Job
 Chabot College Modernization Bldg 300 & 500

Chabot College Modernization
of Buildings 300 and 500
Chabot-Las Positas Community College District
HMC # 3342002, DSA #01-109151

ADDENDUM NO. 5

Scale 1"=20'	Project No. 3342002
Ref. sheet No. C401	Date 01/12/09
	Drawing No. AD2-01

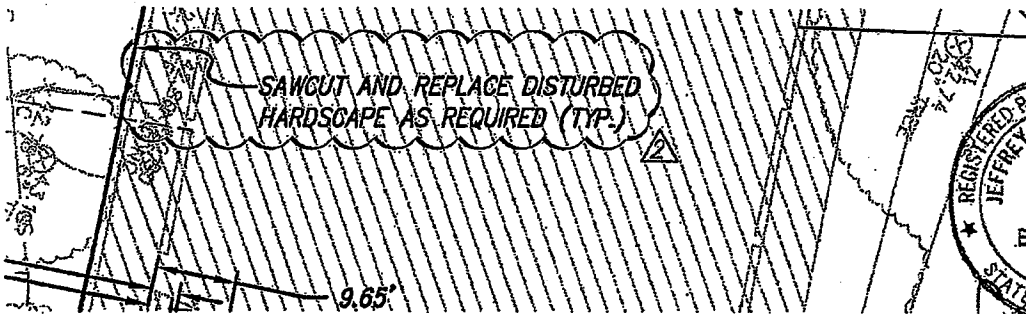
AD2-C1
AD2-E1
AD2-F1
